STATE OF NORTH CAROLINA DEPARTMENT OF TRANSPORTATION

Addendum No. 1

RE: Contract # C204732 WBS # 45565.3.1, 45565.3.2 FEDERAL-AID NO. 0012068 **Dare County (B-5610)** BRIDGE #270008 OVER THE SLASH CREEK ON NC-12 AND SR-1241(EAGLE PASS RD) FROM NC-12 TO NC-12

12" PRESTRESSED CONCRETE PILE

REVISIONS						SHEET NO.
NO.	BY:	DATE:	NO.	BY:	DATE:	S-25
1			3			TOTAL SHEETS
2			4			29

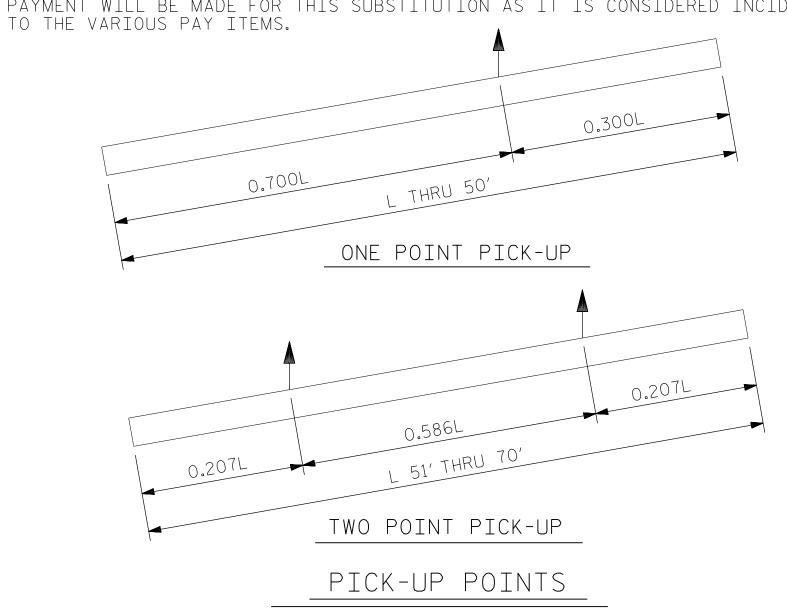
Sheet Nos.	Revision
S-25	Steel Pile Tip details removed

Please void the above listed Sheet in your plans and staple the revised Sheet thereto.
